PRODUCT BULLETIN

Bulletin No: PB287

Power Switch for Hakko 485,HJ3080,700 Series

485-63

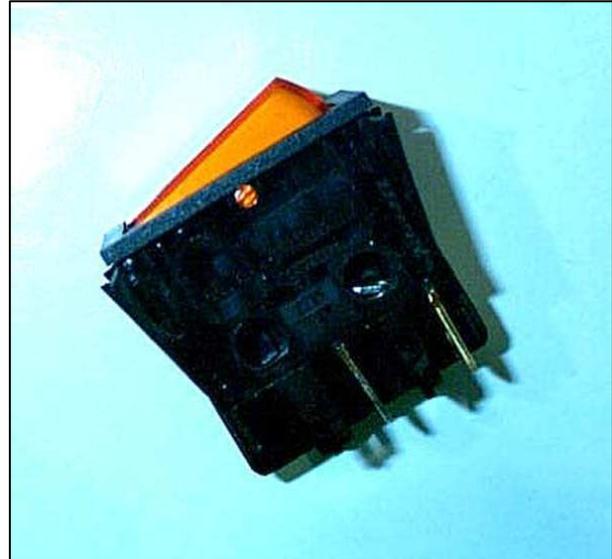
Hakko has changed the source for this power switch and as a result, the pin assignment for wiring has been changed.

Connection	Old Switch	New Switch
Power Supply Side	Connect 1 to 4	Connect 1 to 3
Load Side	Connect 2 to 5	Connect 2 to 4
